Technical Bulletin

Bulletin: Floatfix.doc

To all Elite and Rebel Builders:

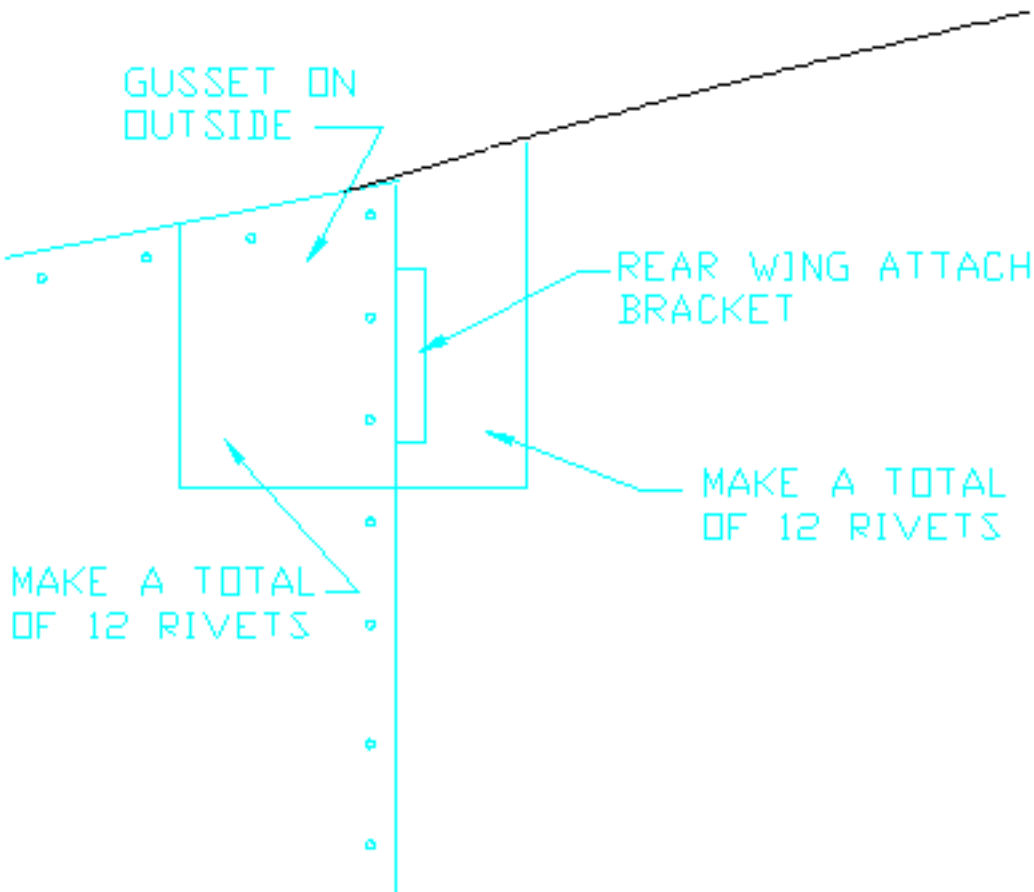
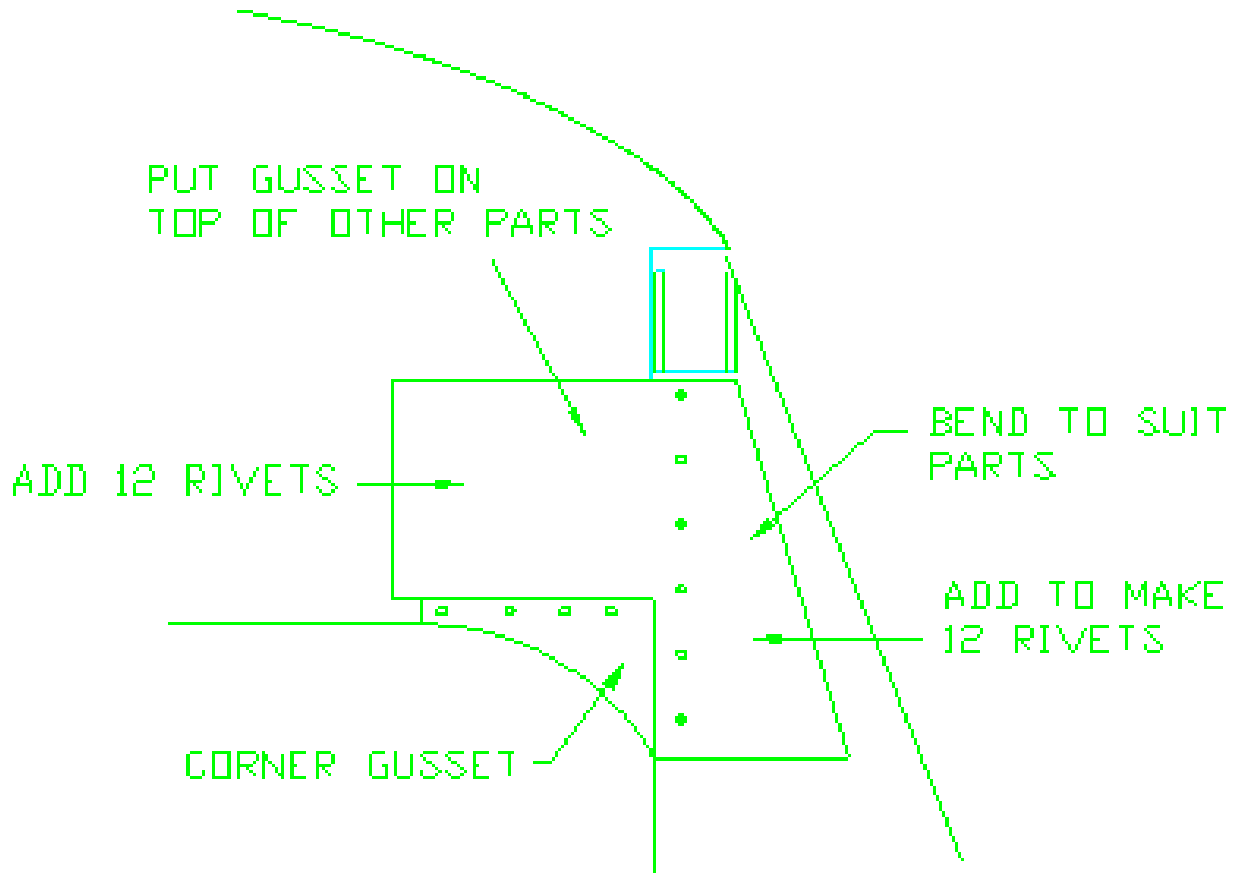
It has come to our attention that aircraft on floats, especially those that put on the larger engines and do not move the firewall back, have developed small cracks on the firewall around the top engine mounts. Also there was slight deformation in the skins around the top of the door posts causing the rivets to shear.

1) Firewall: On the firewall you will need to place a channel across the top between the two engine mounts. A 2" piece of channel should be used to accomplish this. On the existing firewall there are two pieces of witches hat section (FUS-12) that are on the front and back, therefore the new channel must be installed in two pieces with a 6" overlap. One piece of the channel will go on the back of the firewall sandwiched between the top engine mount bracket and the firewall. The other piece will go on the front of the firewall between the engine mount and the firewall. There are already existing parts in this area (dashboard brace, etc.) so you may need to stagger the overlap to one side or the other to accommodate them. Use a nominal 1" rivet spacing to attach the channel and a 3/4" rivet spacing on the overlap.

2) Door Posts: .032" doublers are needed on the top front and rear door post. See figures for the locations and approximate sizes of the doublers. Add rivets so that you get a total of twelve rivets on each side of the overlap on each doubler.
